Kansas Department of Agriculture
 Division of Water Resources
CHANGE: P/U WORKSHEET

WATER RIGHT NO. 47468

CHANGE IN PLACE OF USE APPLICATION MAP

Re: Place of Use Change Applications
File Nos. 39205, 41255, 42159, 47468 – Larry L. Stucky

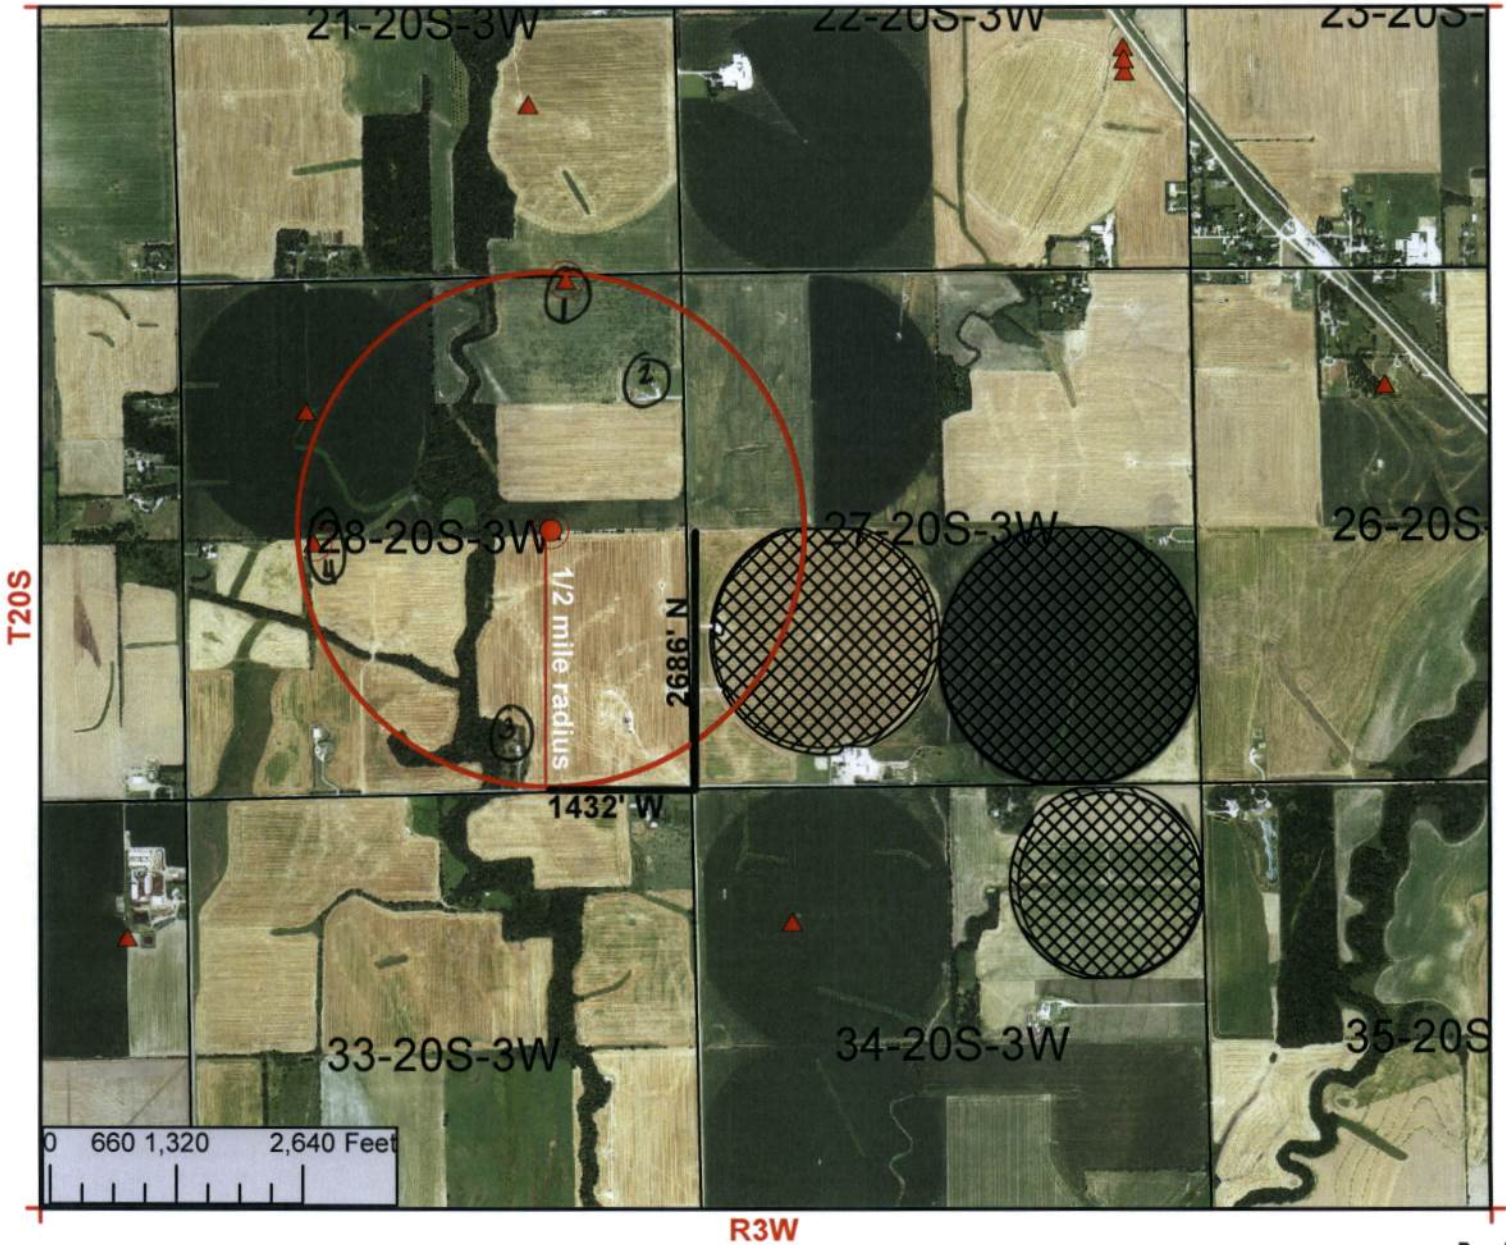
7. The changes herein are desired for the following reasons?
 (please be specific) Change place of use to cover
unauthorized acres.

The change applications propose to modify the places of use and create an identical place of use overlap between the water rights/permit totaling 295 acres. The proposed place of use results in a total combined water to land ratio of 1.27 acre-feet per acre.

2. On and after the effective date of this summary order, the authorized place(s) of use shall be located substantially as shown on the topographic map accompanying the application to change the place of use. Applicable Not Applicable

The District's review found that the change applications comply with the Revised Aquifer Management program approved by the Chief Engineer and with the District's Rules and Regulations K.A.R. 5-22-1 through 5-22-17. Based upon the review, the applications are recommended for approval by the Equus Beds Groundwater Management District No. 2.
